**GARVEY ELEVATOR SITE
WORK PLAN AND FIELD SAMPLING PLAN ADDENDUM FOR
REMEDIAL INVESTIGATION ACTIVITIES**

TO: Brian Zurbuchen, PhD, EPA Task Order Project Officer
FROM: [REDACTED] P.G., HGL [REDACTED]
THROUGH: [REDACTED], HGL Program Manager
DATE: February 23, 2010
SUBJECT: Work Plan Addendum for Remedial Investigation Activities, Garvey Elevator Superfund Site, Hastings, Nebraska
CONTRACT NO: EP-S7-05-05
TASK ORDER NOs: 0033 and 0034

**WORK PLAN AND FIELD SAMPLING PLAN
ADDENDUM
REMEDIAL INVESTIGATION/FEASIBILITY STUDY
GARVEY ELEVATOR SITE
HASTINGS, NE
TASK ORDERS 0033/0034**

Figure 2
Proposed Off-Site Monitoring Wells
Construction Diagram
Garvey Elevator Site—Hastings, NE

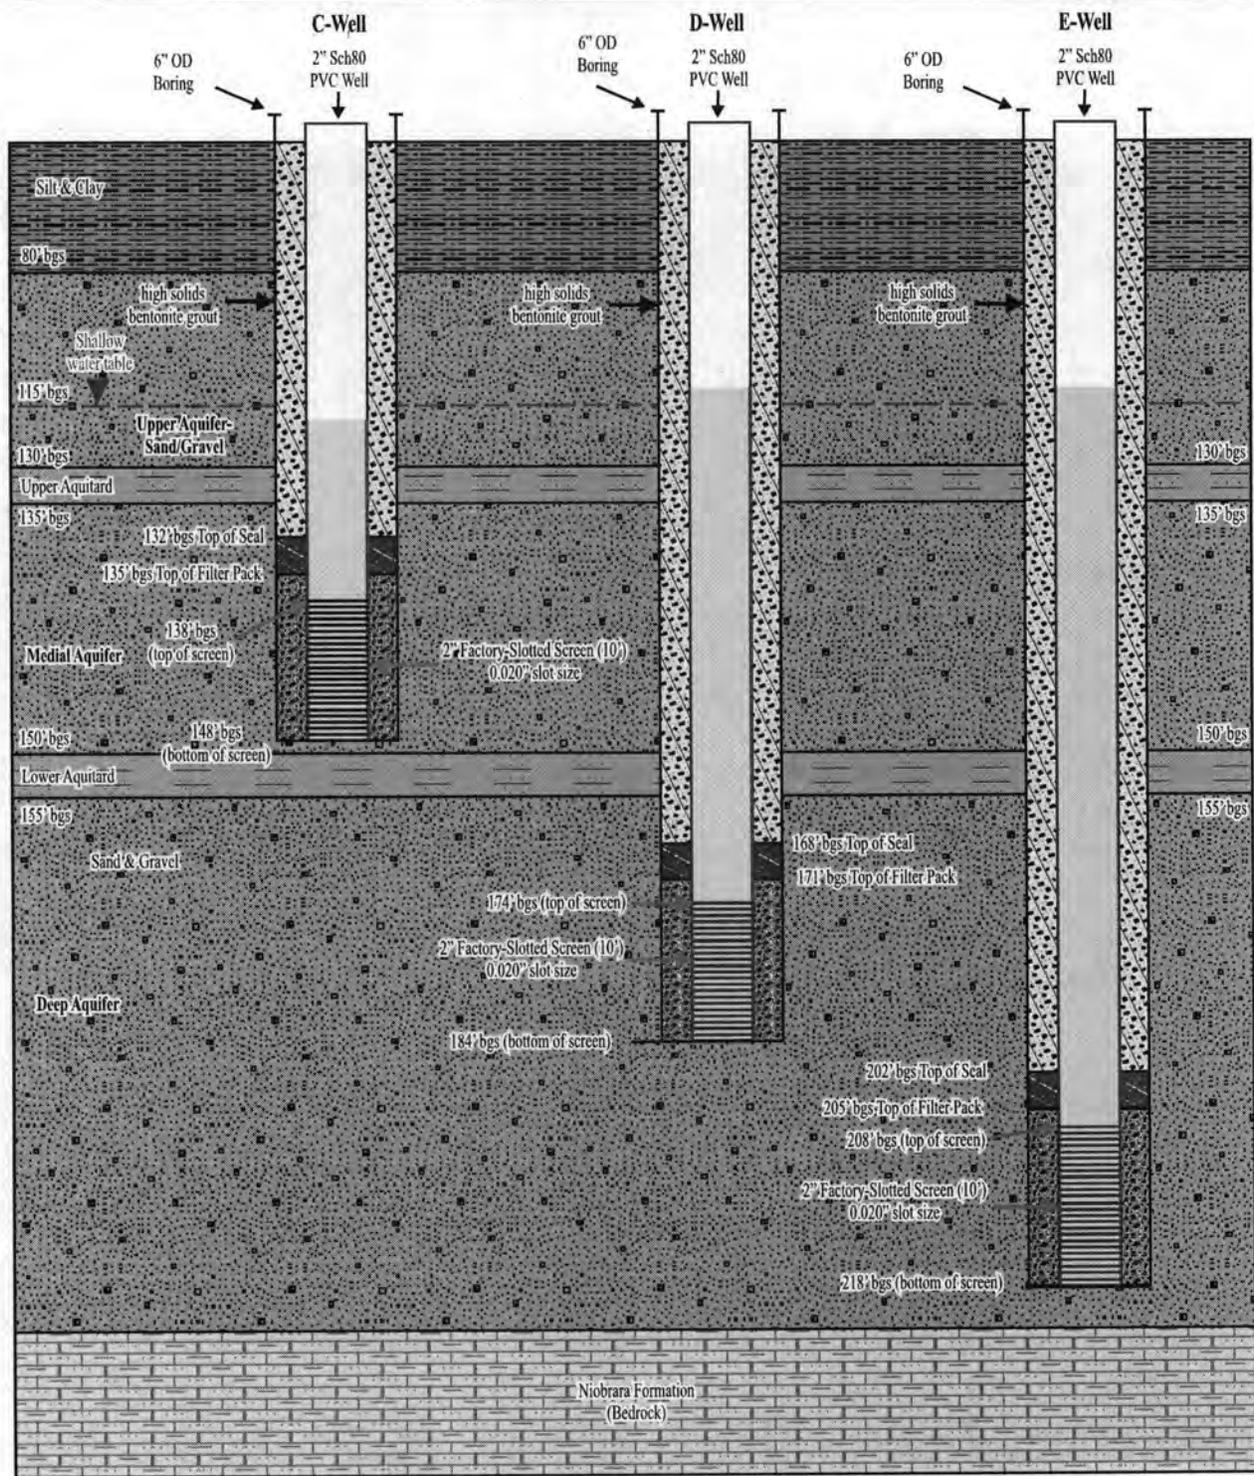
Figure 2 is a construction diagram for 2-inch monitoring wells. Before mobilizing for the well installation, ground surface elevations will be surveyed at each proposed well location. Survey data will be used to determine the drilling depths required to screen particular elevations within the aquifer at each proposed location.

1. Using the mud rotary drilling method, a 6-inch diameter outside diameter (OD) borehole will be advanced to depth necessary to install the screen at the appropriate elevation.

2. The 2-inch schedule 80 polyvinyl chloride (PVC) well casing and factory-slotted 10-foot screen (0.020-inch slot) will be lowered into the borehole so that the screen top and bottom coincide with the pre-determined depths to match the proposed screened interval elevations.

3. Filter pack sand with a #16-#30 gradation will be placed into the annular space, against the screen to a point approximately three feet above the top of the screen.

4. A 3-foot bentonite chip seal will then be placed in the annular space between the boring wall and the 2-inch well casing above the filter pack.
5. High-solids bentonite grout will be emplaced using a side-discharge tremie pipe from the top of the chip seal to within 3 feet of the ground surface.

6. The wellhead will be secured within a lockable steel stickup well protector set in a 2-foot by 2-foot concrete pad and extending to approximately 2.5 feet above the ground surface. Steel bollards will be installed around the well pad. Alternatively, if a stickup completion is not allowed, a circular, bolt-type flush-mounted security well vault will be cemented in the center of the well pad.
